UNION STUDIO
ARCHITECTURE & COMMUNITY DESIGN

ADDENDUM

ADDENDUM NO.: 3
DATE: 06/27/16
PROJECT: CHW | ChurchWoods
PROJECT ADDRESS: 4130 Old Post Road
Charlestown, RI

ES100

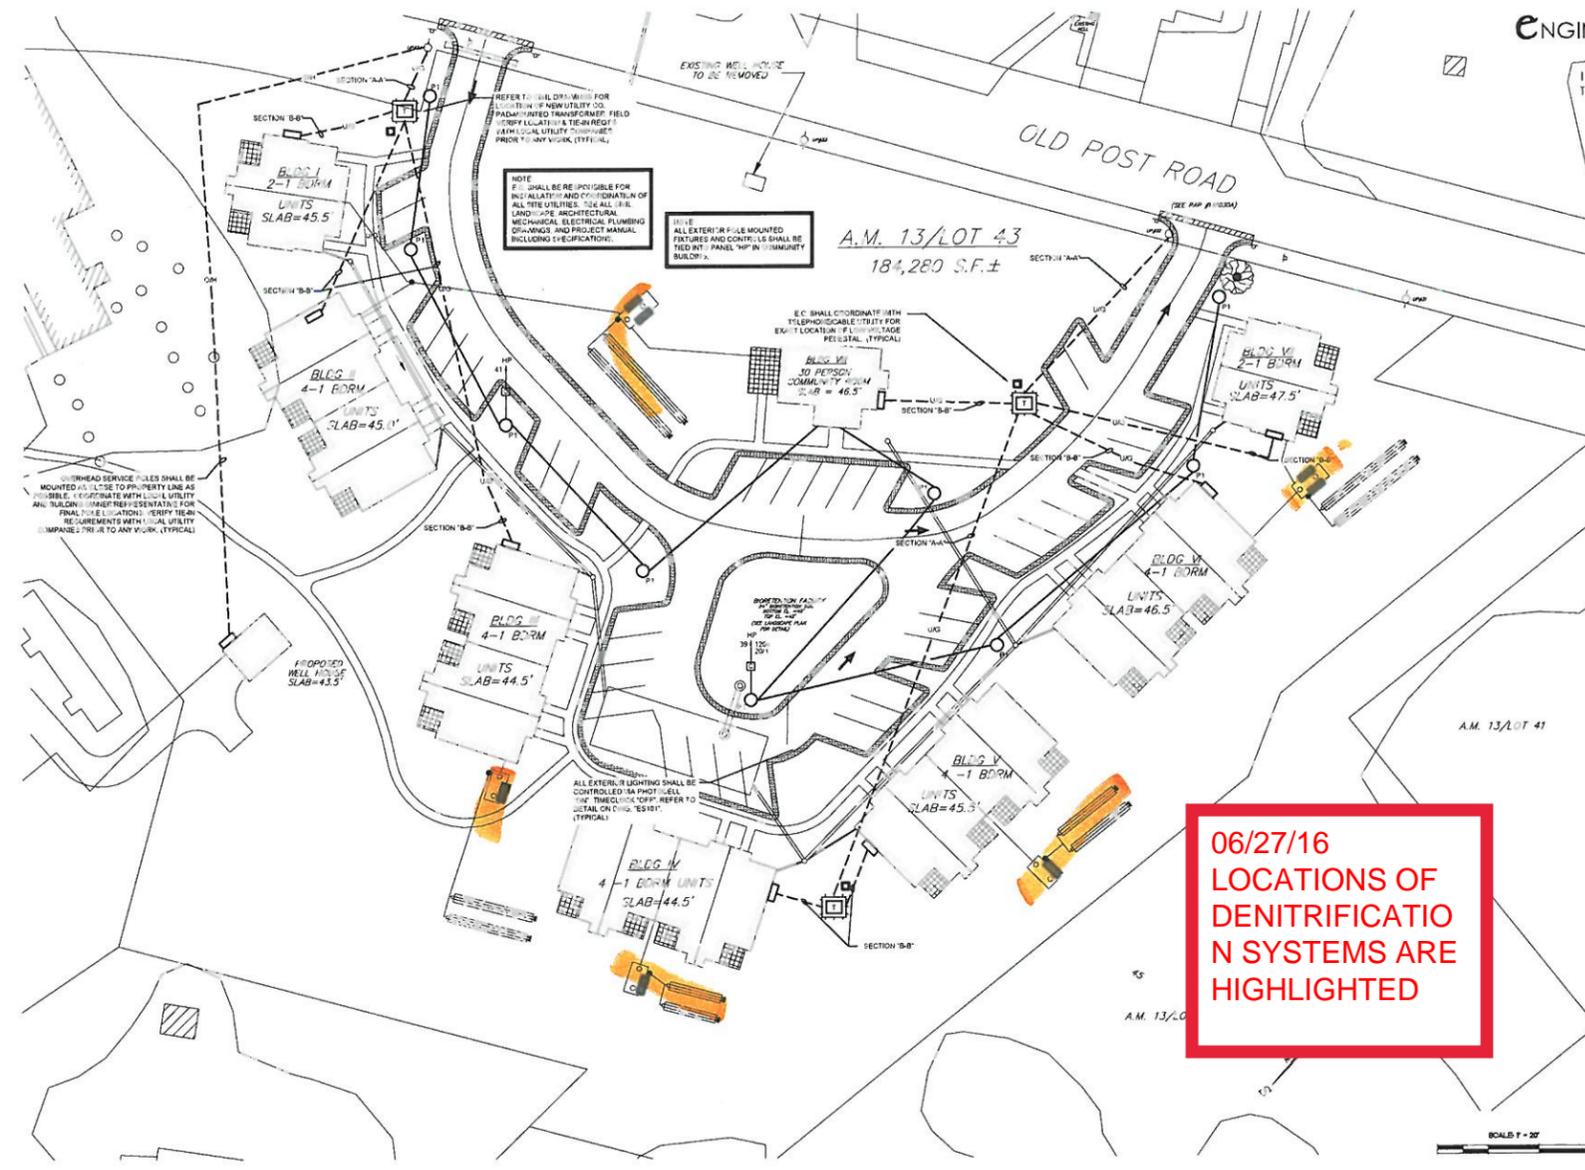
7. Question: On drawing ES100 there is a "DENITRIFICATION SCHEDULE" for pump wiring, where are the pumps? Could you please clarify locations of Denitrification Systems

15. Question: Could you please clarify locations of Denitrification Systems:

06/27/16
LOCATIONS OF DENITRIFICATION SYSTEMS ARE HIGHLIGHTED

Answer: See attached marked up plan ES100 and civil drawing C4.

Answer: See attached marked up plan and civil drawing C4.
